PREVOST

**WARRANTY
BULLETIN**

Wb09-13A

DATE : MARCH 2010	SECTION : 05 - Cooling
EXPIRATION: MARCH 2012	
SUBJECT : INSPECTING THE RADIATOR FAN DRIVE MECHANISM SUPPORT ON A DETROIT DIESEL ENGINE

FIGURE 1: SUPPORT # 550919

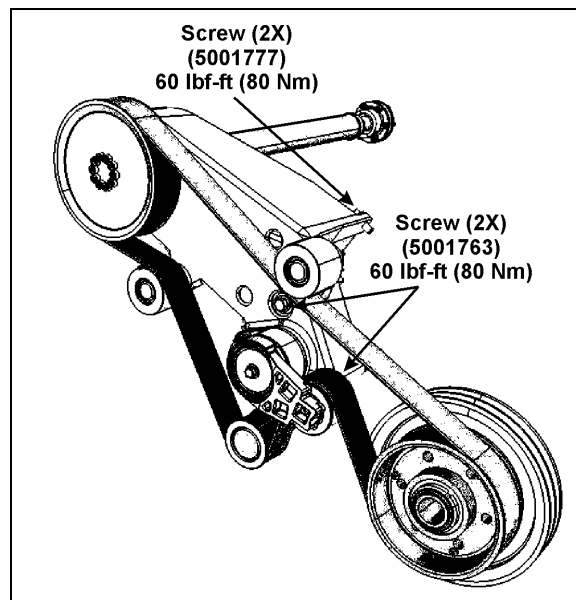
1. After inspecting the radiator fan drive support, for purpose of reference, mark cap screw heads and support.
2. Torque radiator fan drive mechanism support short cap screws to 60 Lb-ft (80 Nm) (Refer to figures 1 and 2).
3. If the two cap screw heads do not move, the verification is complete; there is nothing to replace.
4. If the two cap screw heads move but less than $\frac{1}{4}$ turn (90° angle), replace the two short cap screws with new ones (5001777).

5. First pre-torque cap screw heads to 25 Lb-Ft (34 Nm).
